PIC24FJ64GA104 Family Silicon Errata and Data Sheet Clarification

The PIC24FJ64GA104 family devices that you have received conform functionally to the current Device Data Sheet (DS39951C), except for the anomalies described in this document.

Data Sheet Clarifications

FIGURE 2-3: FREQUENCY vs. ESR PERFORMANCE FOR SUGGESTED VCAP

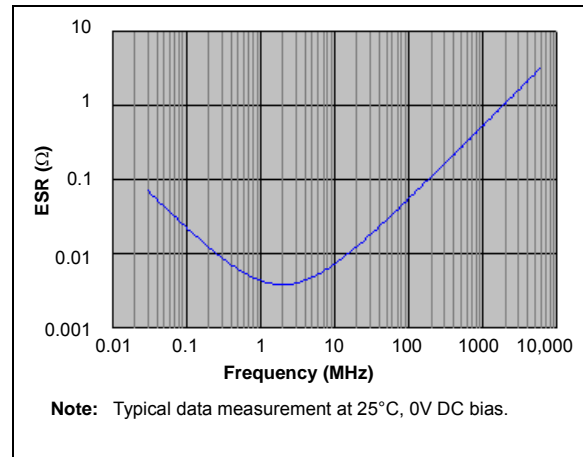
Section 2.4 “Voltage Regulator Pins (ENVREG/ DISVREG and VCAP/VDDCORE)” has been replaced with a new and more detailed section. The entire text follows:

When the regulator is enabled, a low-ESR ($< 5\Omega$) capacitor is required on the VCAP/VDDCORE pin to stabilize the voltage regulator output voltage. The VCAP/VDDCORE pin must not be connected to VDD and must use a capacitor of 10 μF connected to ground. The type can be ceramic or tantalum. Suitable examples of capacitors are shown in [Table 2-1](#). Capacitors with equivalent specifications can be used.

Designers may use [Figure 2-3](#) to evaluate ESR equivalence of candidate devices.

FIGURE 2-4: DC BIAS VOLTAGE vs. CAPACITANCE CHARACTERISTICS

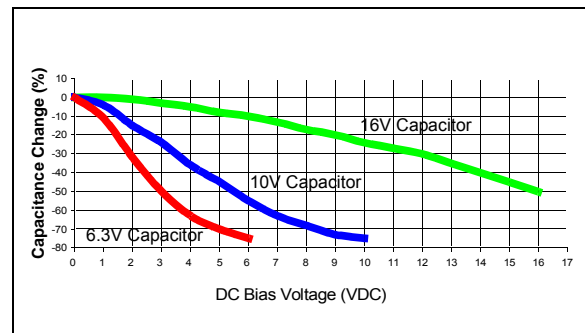
In addition to temperature tolerance, the effective capacitance of large value ceramic capacitors can vary substantially, based on the amount of DC voltage applied to the capacitor. This effect can be very significant, but is often overlooked or is not always documented.

A typical DC bias voltage vs. capacitance graph for 16V, 10V and 6.3V rated capacitors is shown in Figure 2-4.

When selecting a ceramic capacitor to be used with the internal voltage regulator, it is suggested to select a high-voltage rating, so that the operating voltage is a small percentage of the maximum rated capacitor voltage. For example, choose a ceramic capacitor rated at 16V for the 2.5C core voltage. Suggested capacitors are shown in Table 2-1.
